**Environmental  
Planning  
Commission**

**Staff Report**

**Agenda Item Number: 7  
Project #: PR-2018-001482  
Case #: 2023-01925  
Hearing Date: January 18, 2024**

<b>Agent</b>	Tierra West, LLC
<b>Applicant</b>	Riverside West, LLC
<b>Request</b>	Site Plan – EPC
<b>Legal Description</b>	all or a portion of Tract 1 of Summary Plat Land Division of West Land Development Co., included together with A Tract of land within these 1/4 SE, 1/4 SEC, 34 T10N, and R2E and a Tract of land east of Amole Del Norte Diversion Channel North of Section line of section 34 & 3.
<b>Location</b>	located at 2911 Ervien Ln. SW, north west of the intersection of Ervien Ln and Coors Blvd.
<b>Size</b>	Approximately 42 acres
<b>Zoning</b>	R-MC

POLE MOUNTED CAMERA DETAIL

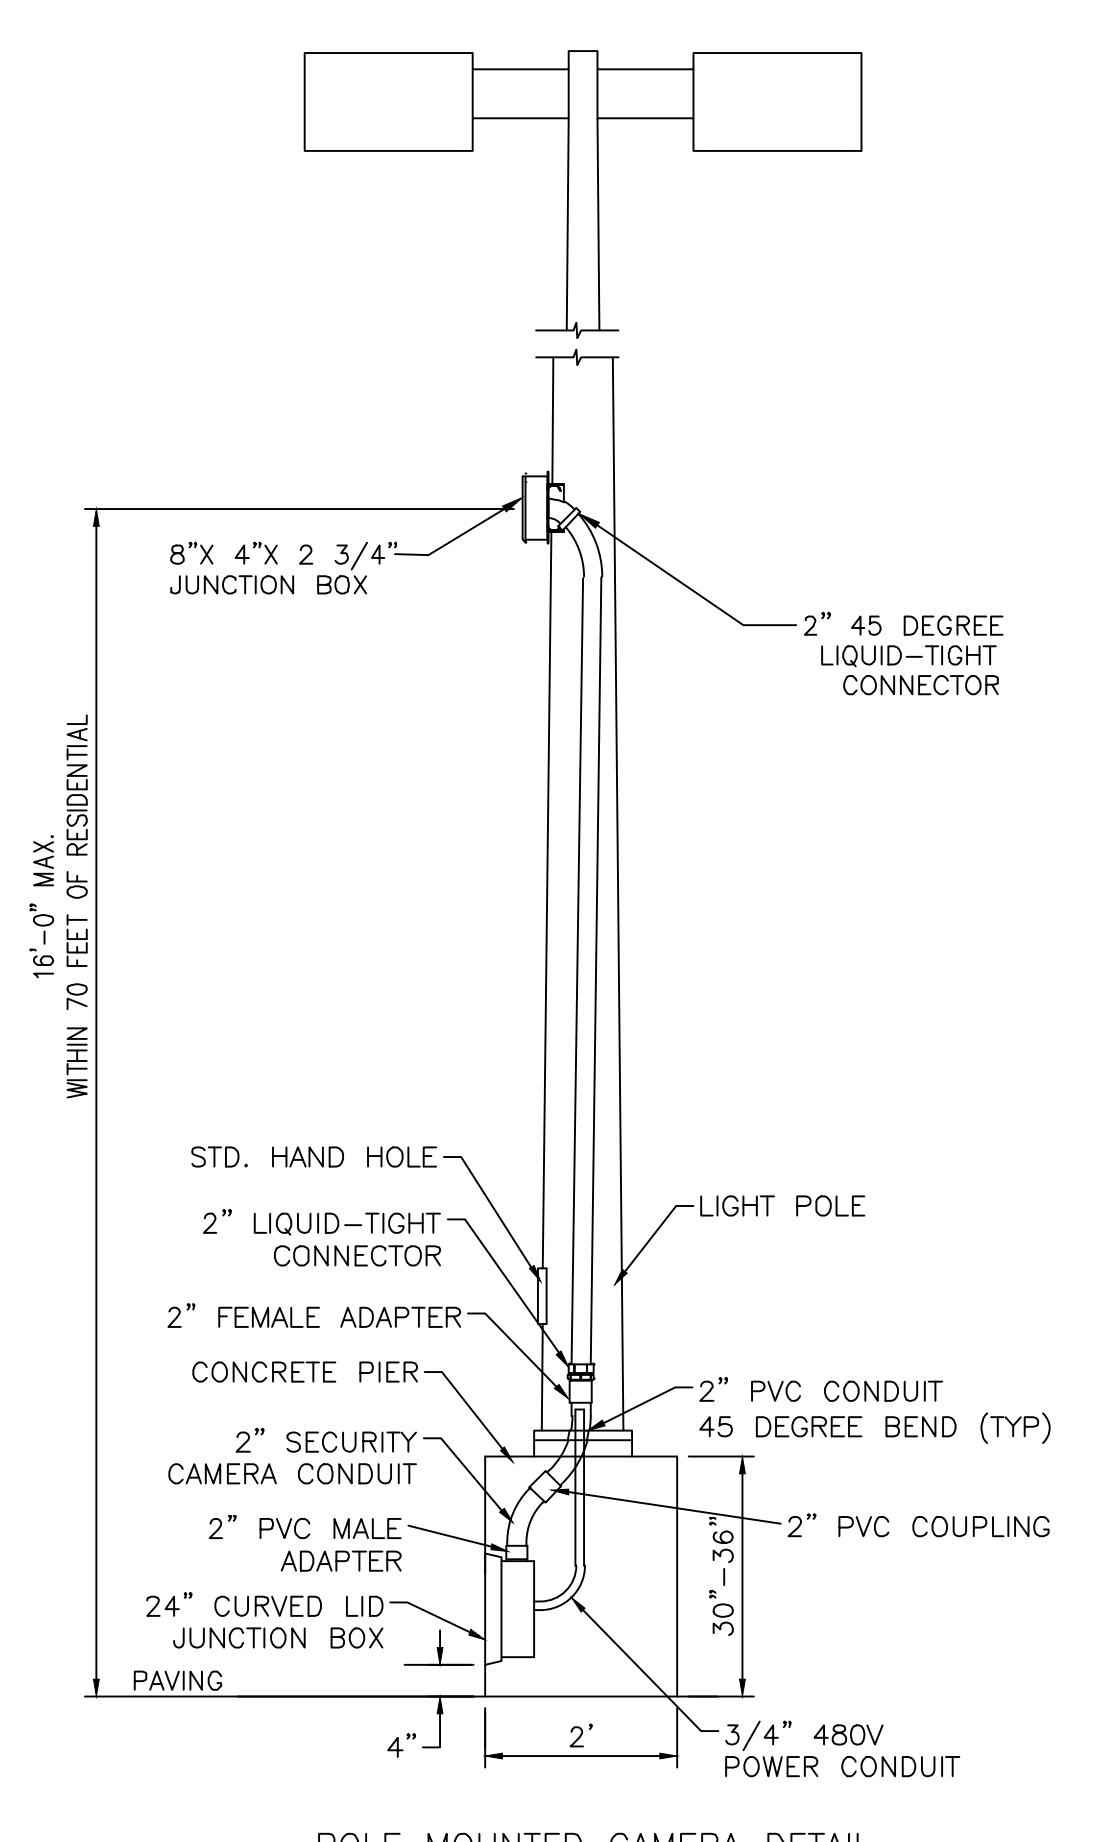
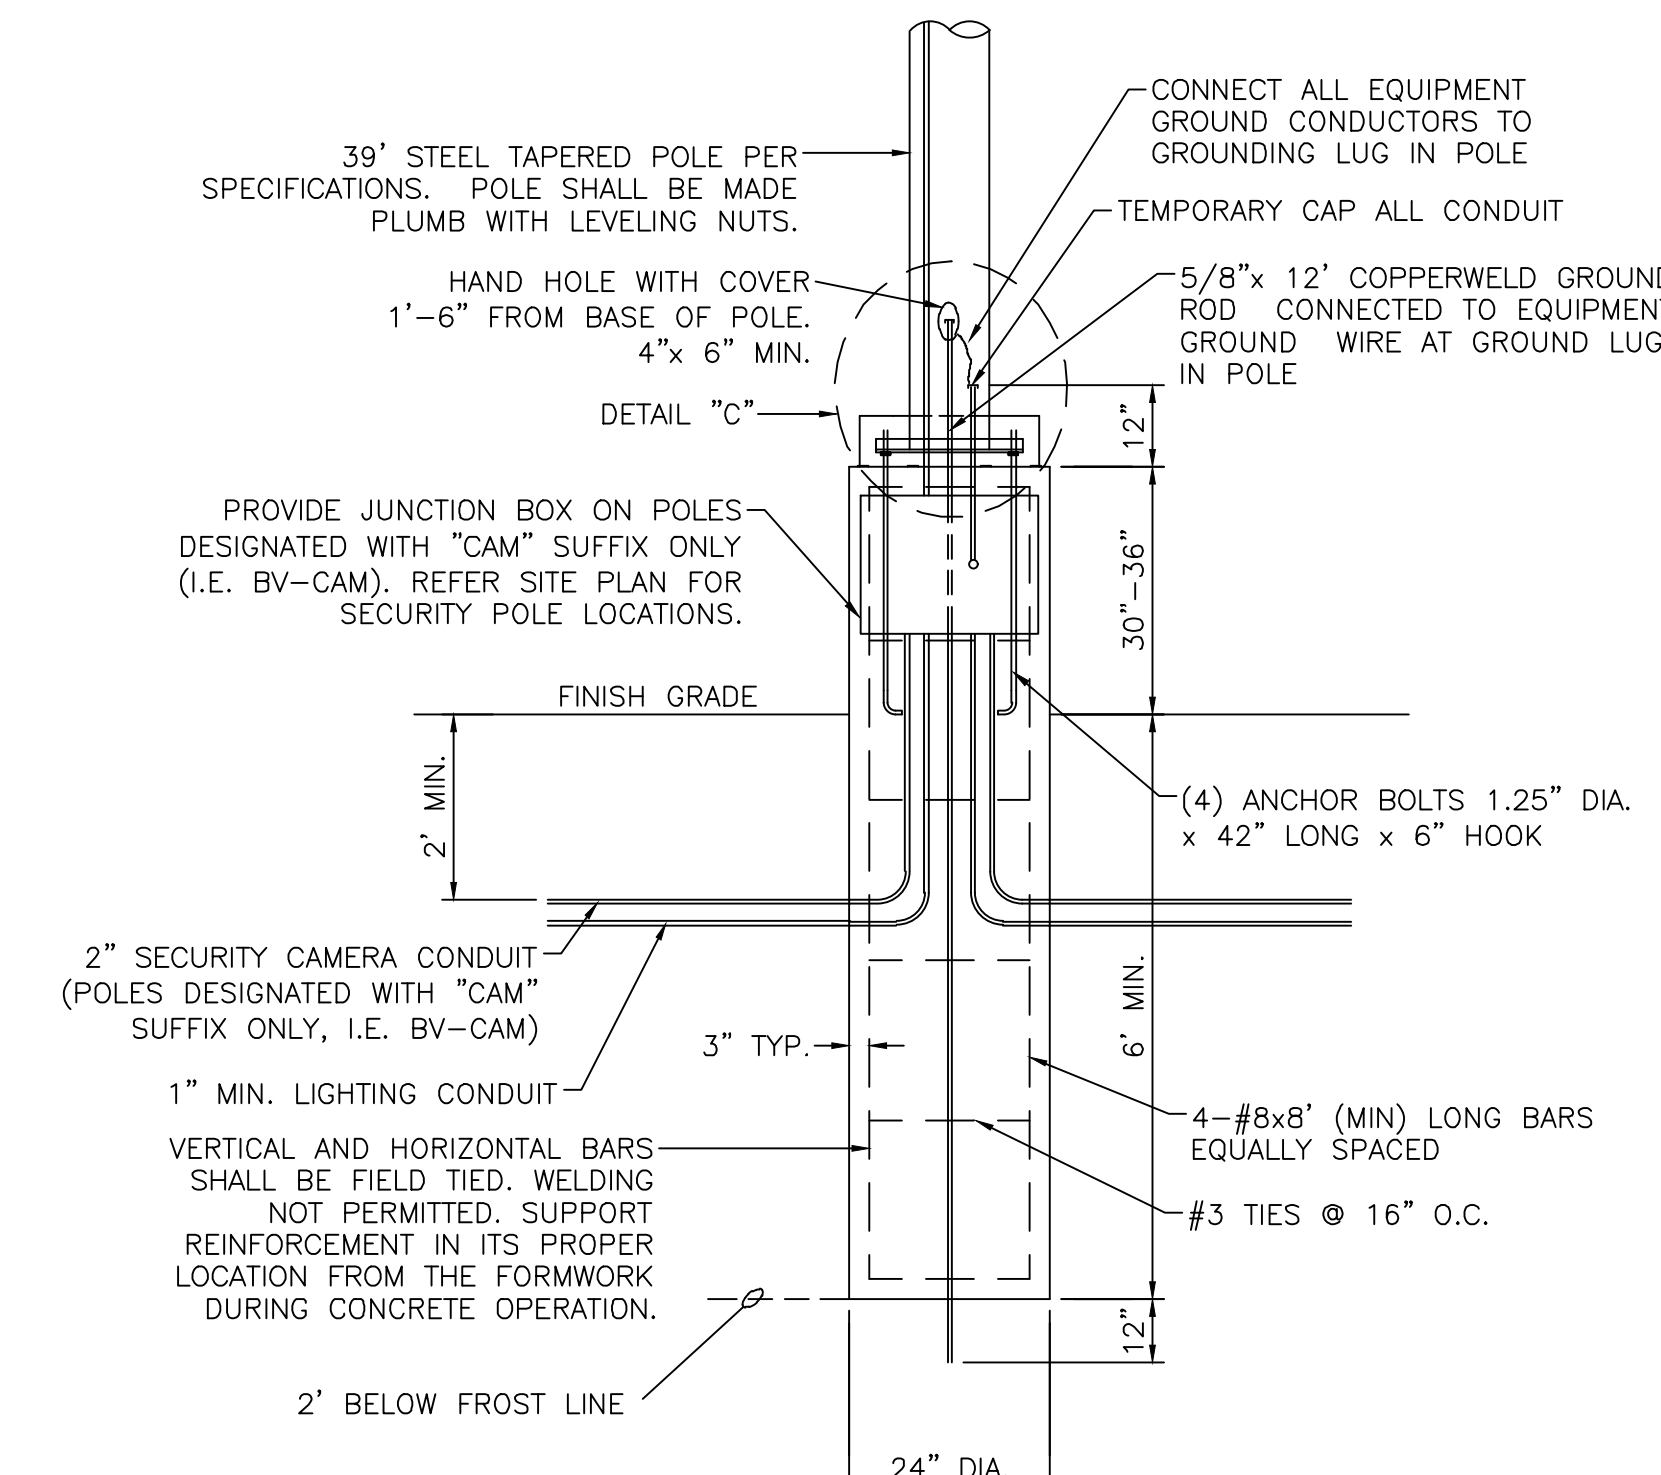
2. The applicant shall coordinate with the Staff Planner prior to submitting to the DFT to ensure that EPC Conditions have been met.
3. Site Plan:
  - A. Note number 3 shall be changed to reflect the light pole maximum of 16' as shown on the Pole Mounted Camera Detail on Detail Sheet C5.0.

6. Detail Sheets: Edit dimension text to reflect 16' Max within 100' of "Residential on the Pole Mounted Camera Detail" on Sheet C5.0.
  7. Condition from Solid Waste Management Department: A site plan approved for access by the Solid Waste Department will be required.
